1992 Corvette: Recall: Instrument Panel/Left Hand Lower Trim/Brake Pedal Interference

Subject: PRODUCT CAMPAIGN 92C10 - INSTRUMENT PANEL LEFT HAND LOWER TRIM PANEL/BRAKE PEDAL INTERFERENCE

Model and Year: 1992 CHEVROLET CORVETTE

Bulletin Number: 92C10 - (04/23/1992)

Figure 1

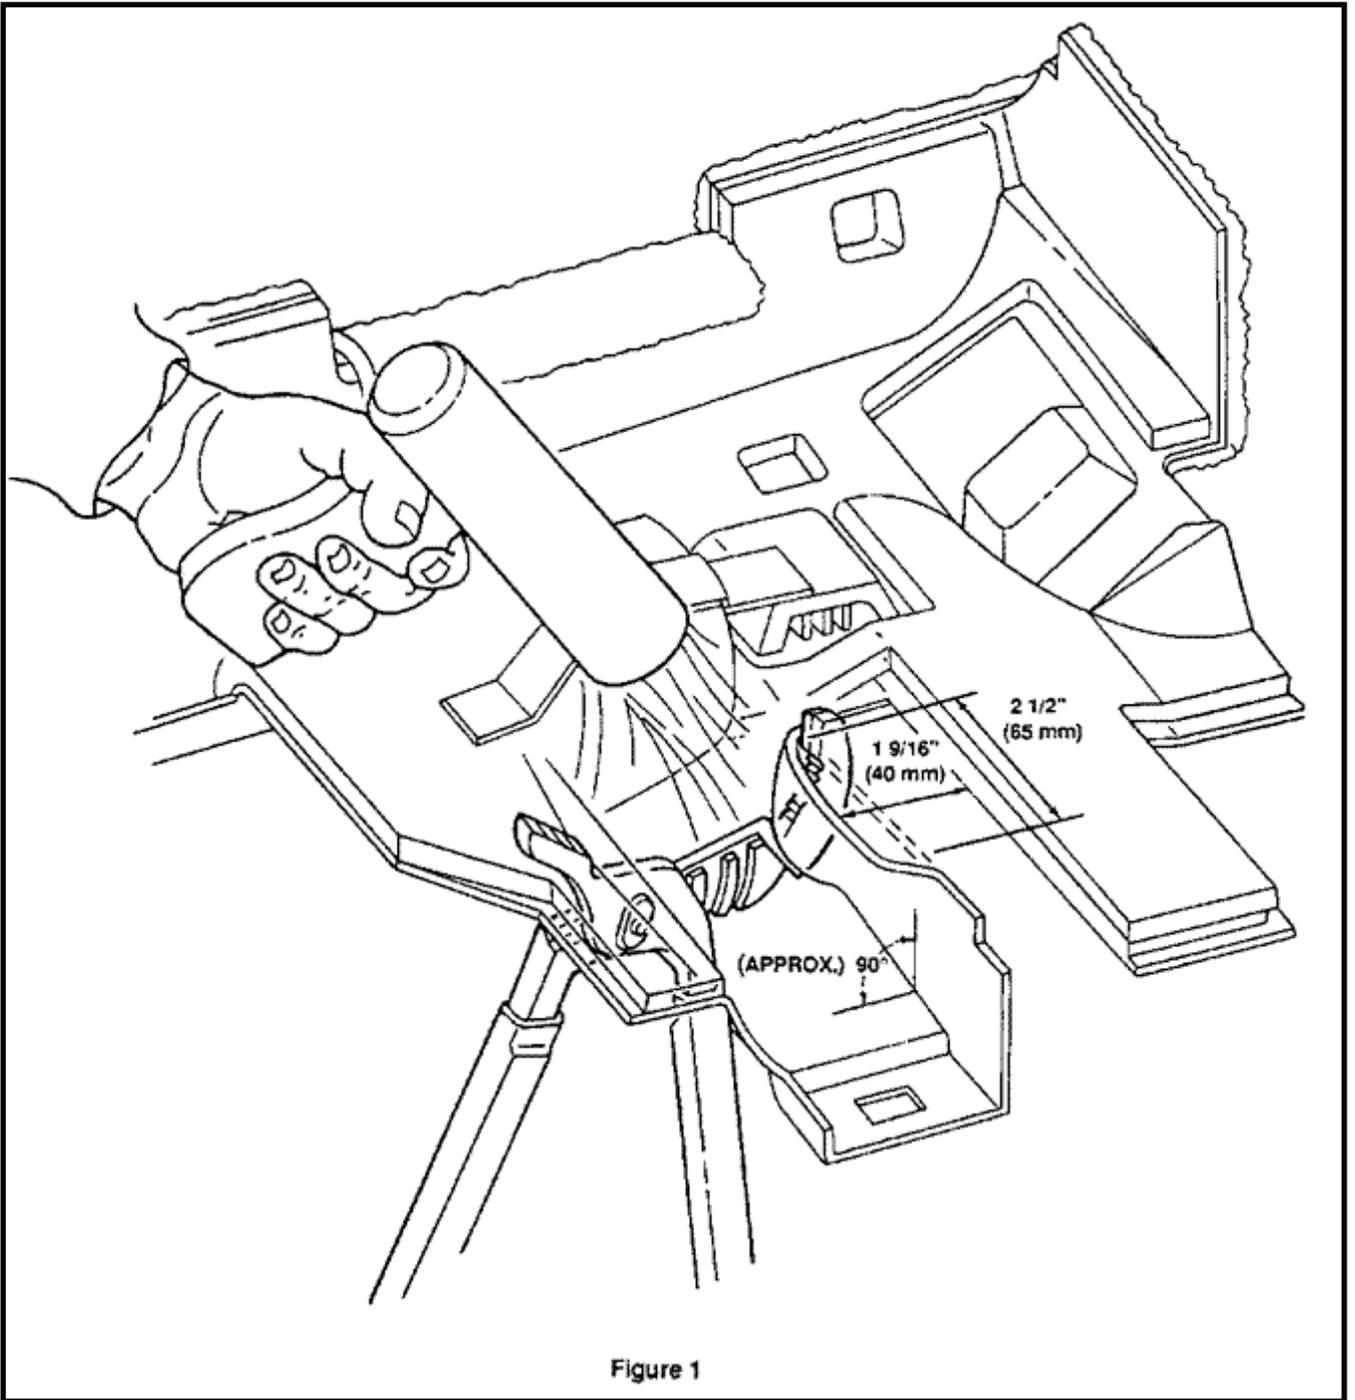
To prevent this condition from occurring, dealers are to inspect for proper clearance between the brake pedal arm and the instrument panel (I/P) left-hand lower trim panel. If clearance is not sufficient, the trim panel will be modified with a heat gun.

Attempt to pass an item approximately 2mm thick (such as a 2mm shim) between trim panel and brake pedal arm on both sides of pedal arm along entire length of pedal travel.

- If 2mm item passes without difficulty, no further action is required. Install Campaign Identification Label.
- If 2mm item does not pass freely, proceed to the "Modification Procedure" below.

1. Remove I/P left-hand lower trim panel (per Preliminary Service Manual, Section 8C-33).
2. Lift away foam sound deadener from area shown in Figure 1 and tape out of way.
3. Using a heat gun, warm trim panel area shown in Figure 1. **USE CARE TO WARM COMPLETE AREA EVENLY.**
4. Using Channel Locks size 16 or larger, place near upper left-hand corner of I/P left-hand lower trim panel as shown in Figure 1. Quickly reform brake pedal opening to configuration and dimensions indicated in Figure 1. If necessary, Channel Locks may be moved downward during initial reforming and/or steps 3 and 4 may be repeated to obtain minimum clearance of 2mm between brake service pedal arm and I/P left- hand lower trim panel.

Notice: To lessen Channel Lock imprint, place smooth shim stock or aluminum face cover between Channel Lock face and warmed surface of I/P left-hand lower trim panel.

5. Reinstall I/P left-hand lower trim panel. Remeasure clearance between trim panel and brake pedal arm along entire length of pedal travel, using "INSPECTION" procedure on page 2.
6. Install Campaign Identification Label.
